# HISTORIC AND DESIGN REVIEW COMMISSION

**HDRC CASE NO:** 2018-451  
**ADDRESS:** 607 E LOCUST  
**LEGAL DESCRIPTION:** NCB 1735 BLK 14 LOT 3  
**ZONING:** MF-33 H  
**CITY COUNCIL DIST.:** 1  
**DISTRICT:** Tobin Hill Historic District  
**APPLICANT:** Jose Calzada/Architectura SA  
**OWNER:** Rafael Saavedra Sada/Aster Development LLC  
**TYPE OF WORK:** Construction of a 3-story, multifamily structure  
**APPLICATION RECEIVED:** November 14, 2018  
**60-DAY REVIEW:** January 13, 2018  
**REQUEST:**

The applicant is requesting conceptual approval to construct a 3-story multifamily structure on the vacant lot addressed 607 E Locust. The request also includes rear surface parking for approximately 8 cars, additional hardscaping, and landscaping.

1 FIRST FLOOR - 827 S.F. EA. APARTMENT UNIT

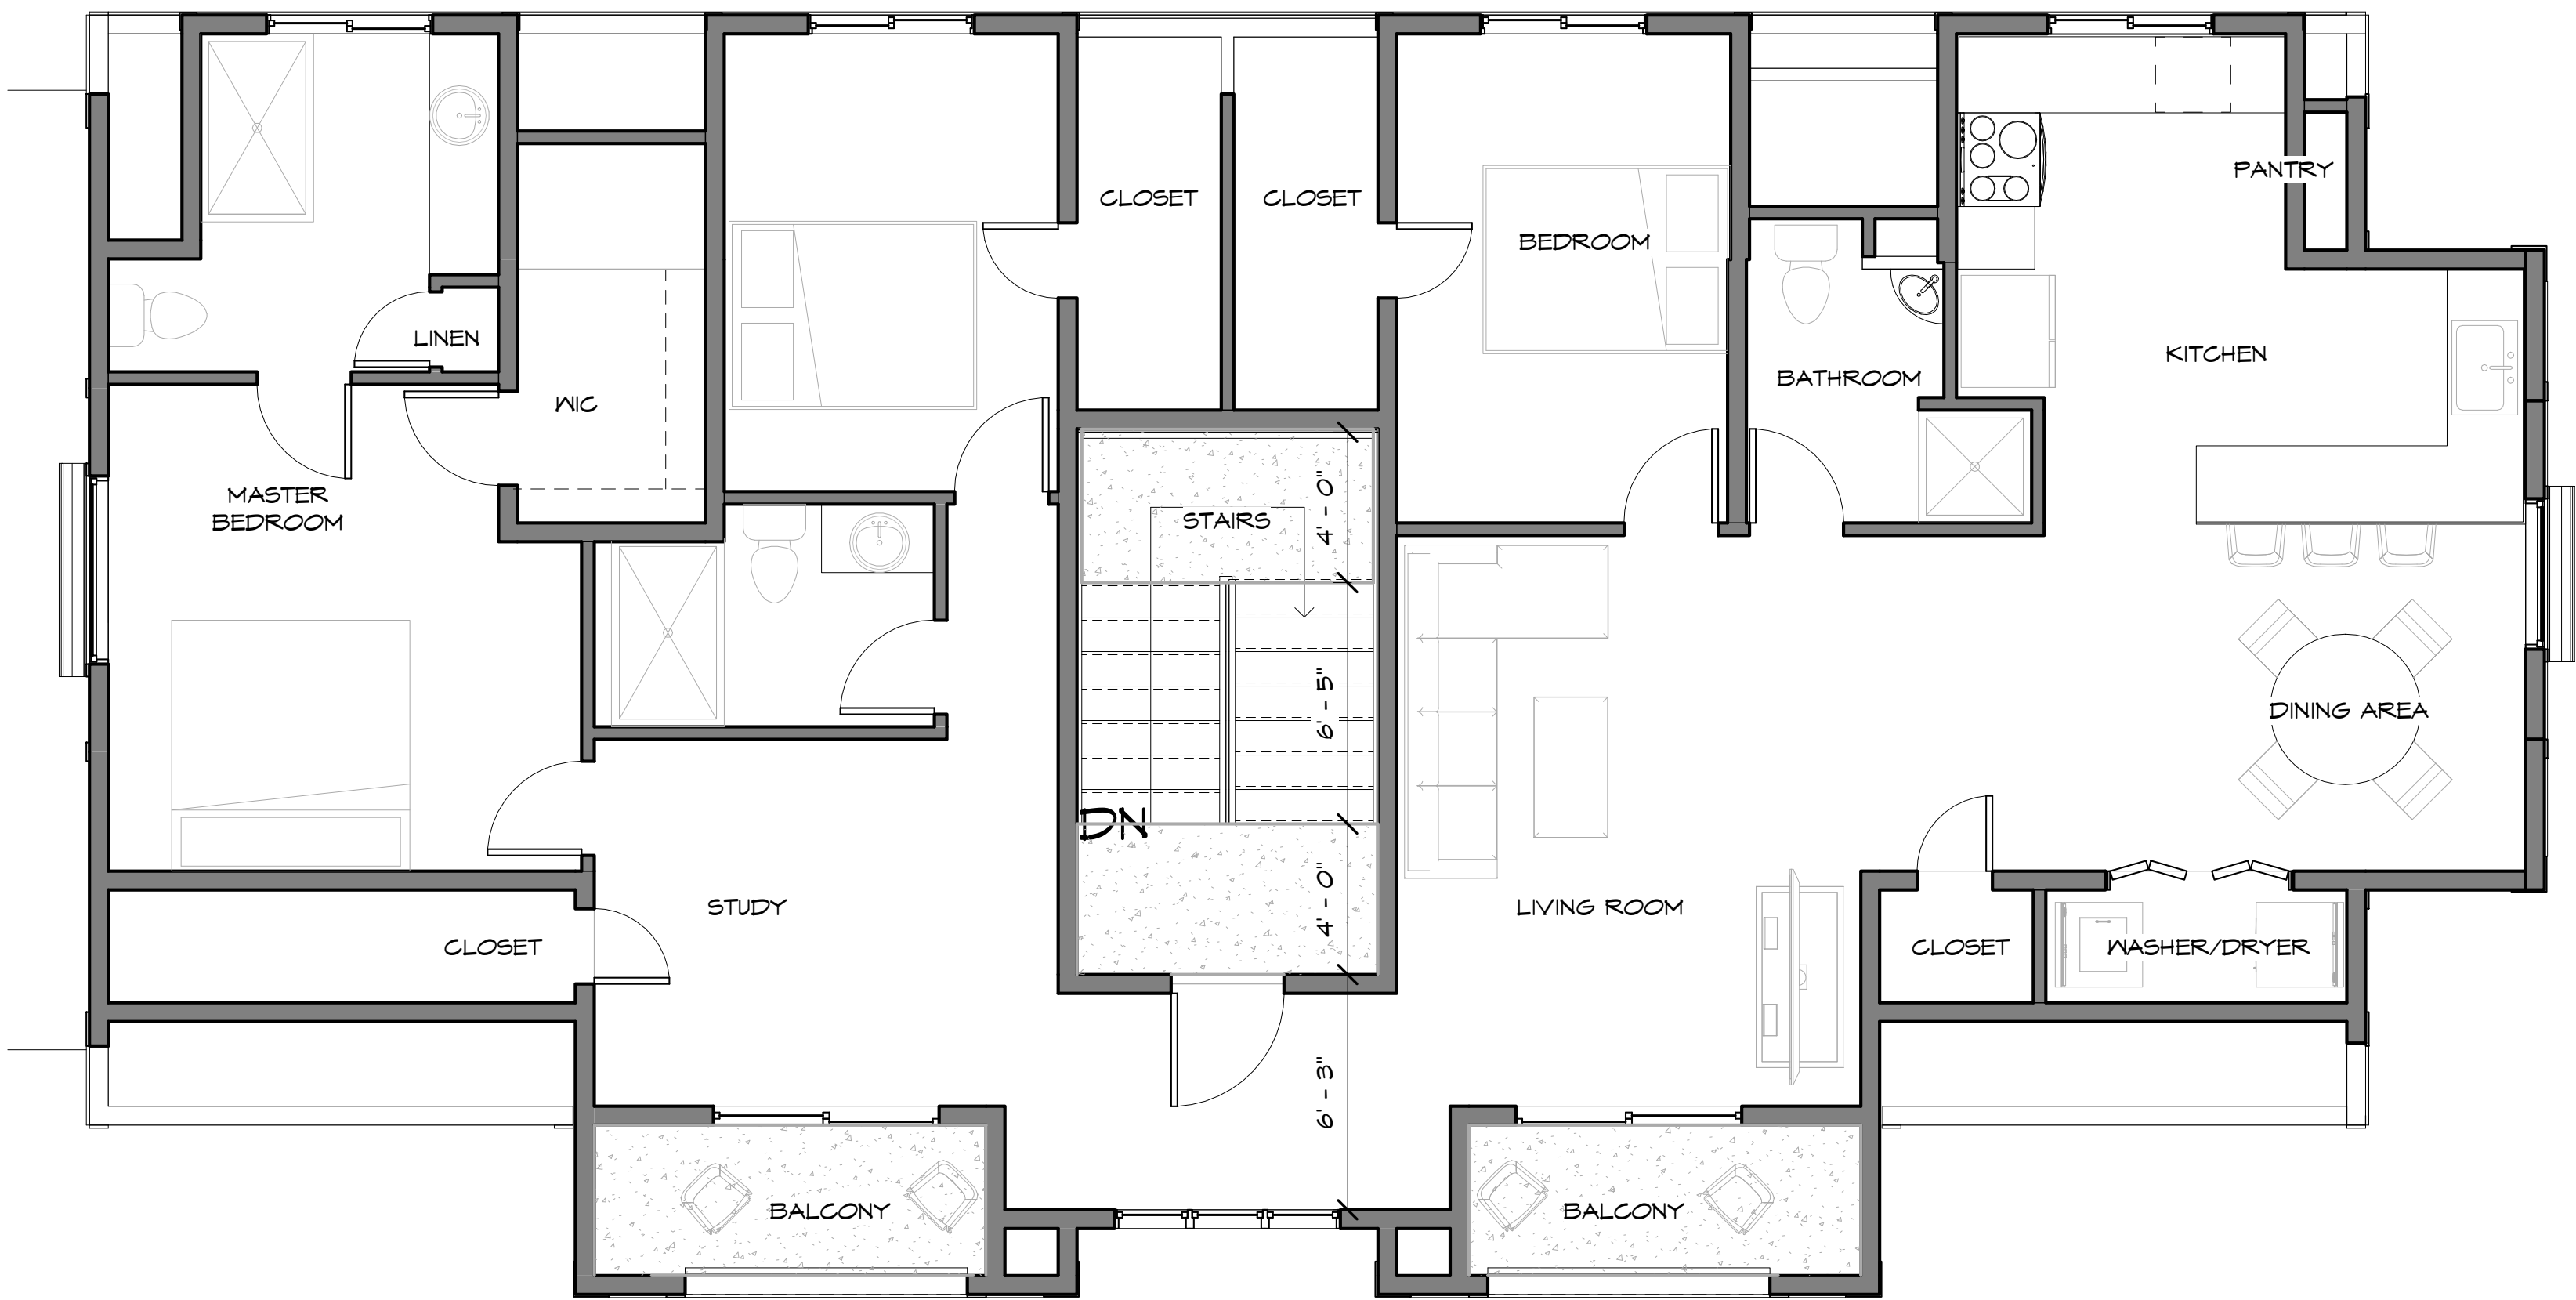
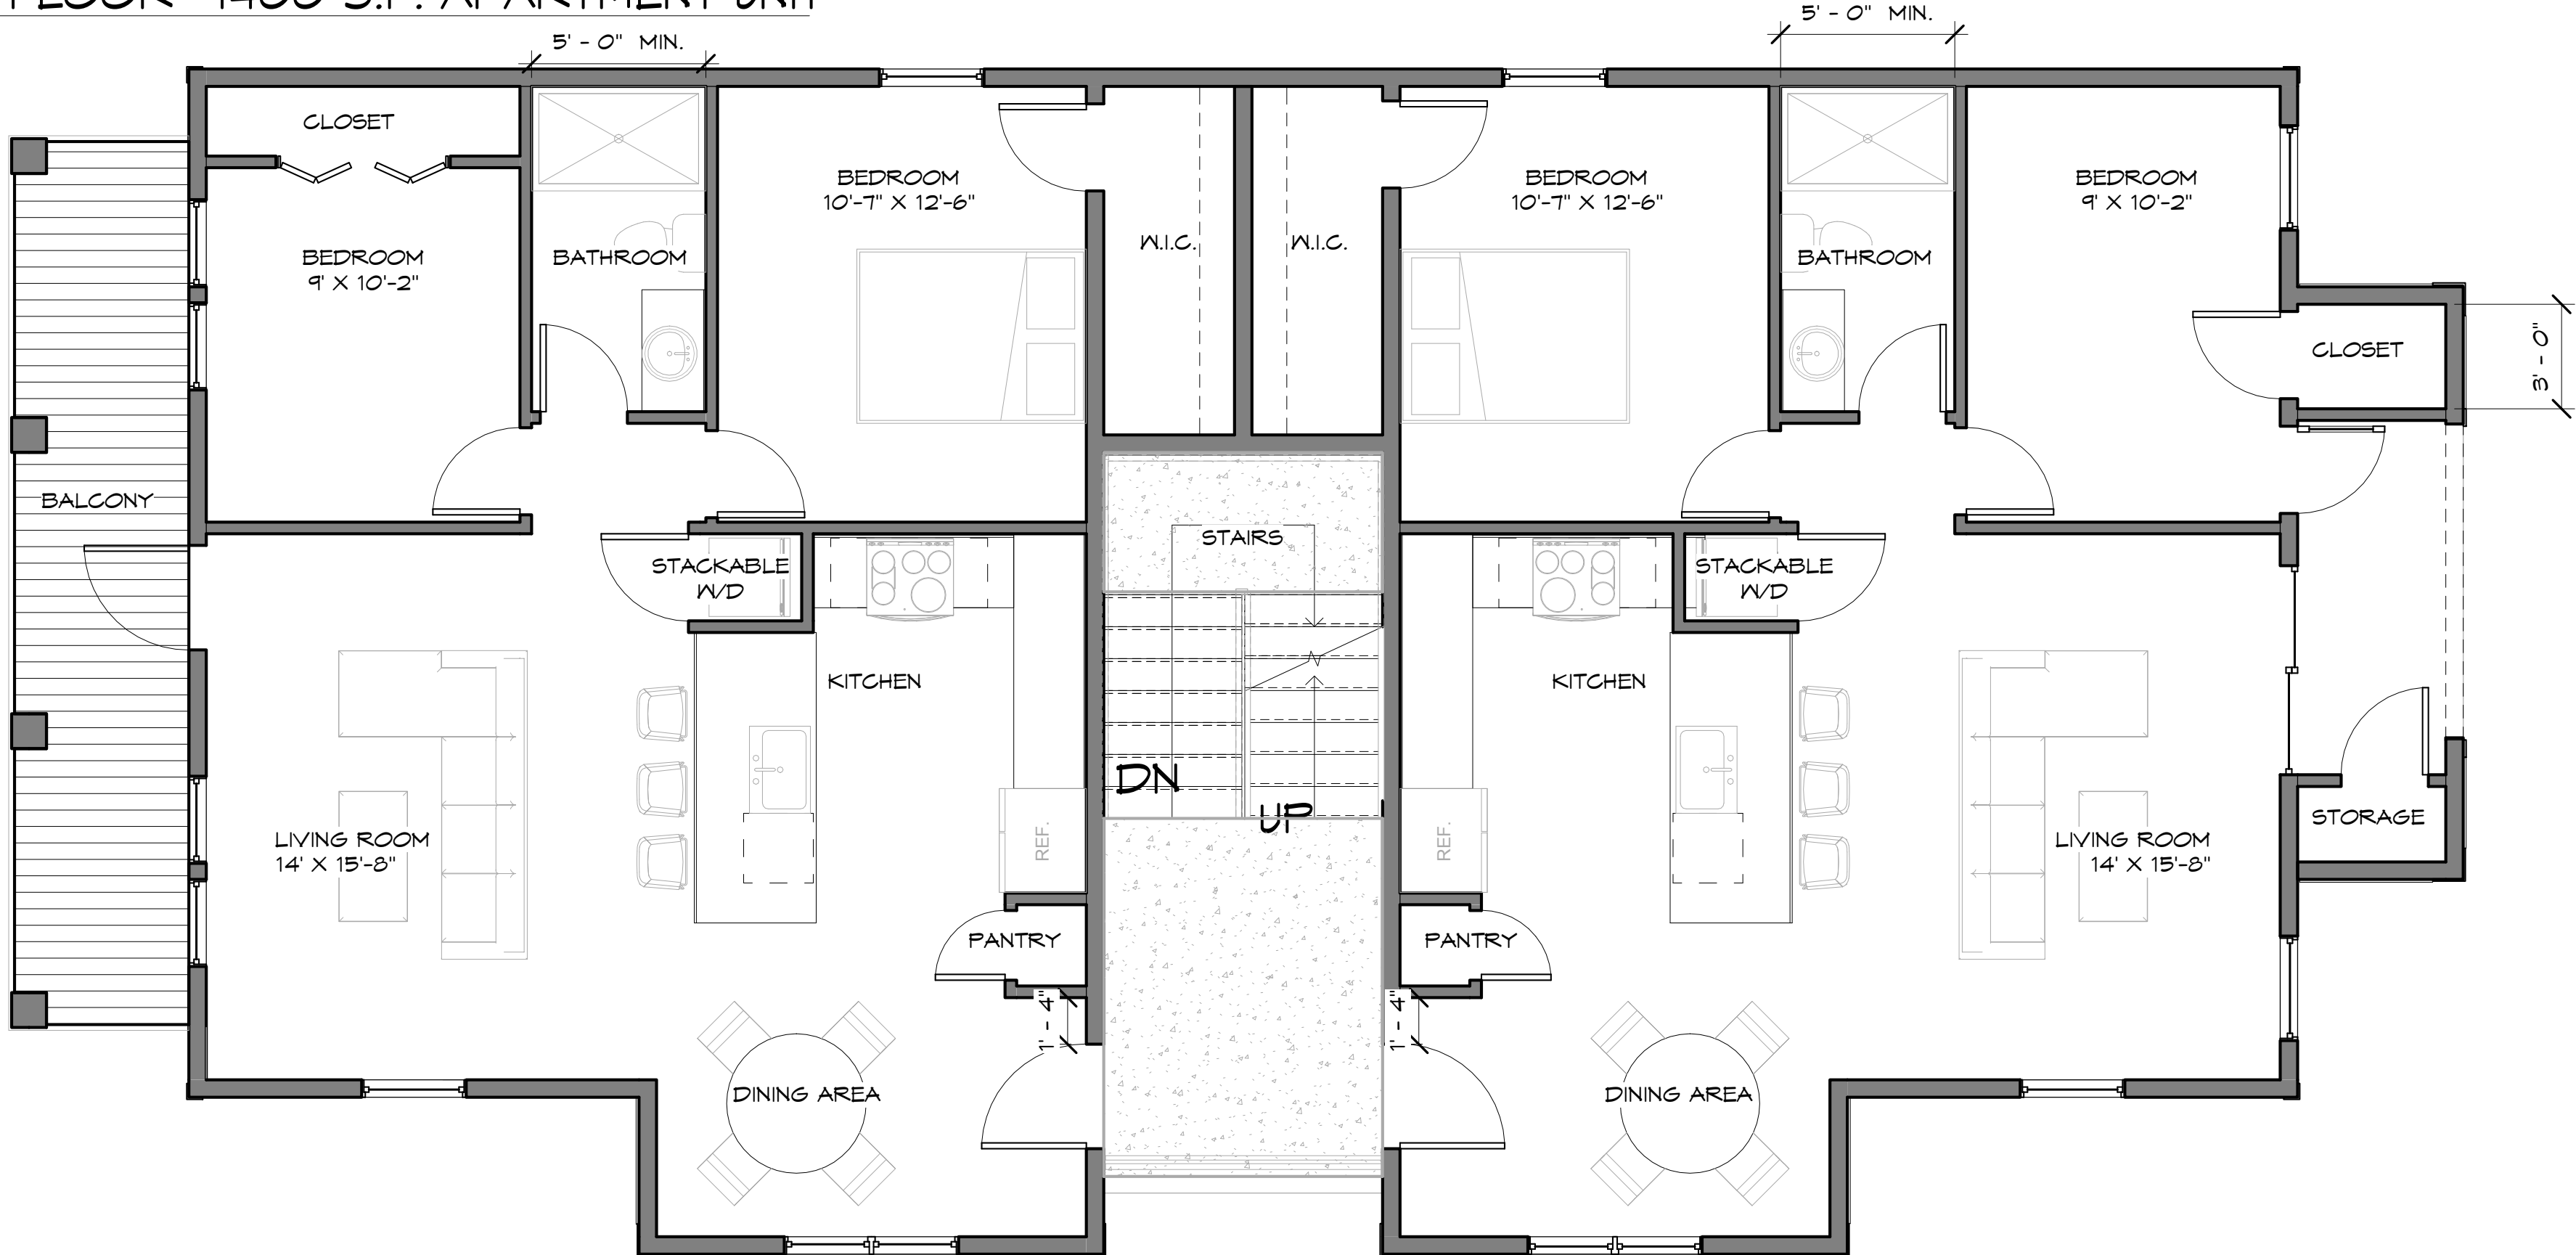
- g. **SCALE & MASS** – The applicant has proposed one, 3-story unit. Per the submitted elevations, the ridgeline of the units is approximately 31'. Guideline 2.A.i stipulates that the height and scale of new construction should be consistent with nearby historic buildings and should not exceed that of the majority of historic buildings by more than one-story. Per the submitted elevations, the applicant has indicated that the 2-story historic structures directly to the east and west are approximately 30-31 feet. Staff finds the overall height to be generally acceptable given the specific context of this portion of the E Locust and the district.

- h. **FOUNDATION & FLOOR HEIGHTS** – According to the Guidelines for New Construction 2.A.iii., foundation and floor heights should be aligned within one (1) foot of neighboring structure's foundations. Throughout this block, the foundation heights of historic structures are between two and three feet. The proposed foundation height is approximately 1.5 feet. Staff finds this consistent with the Guidelines.
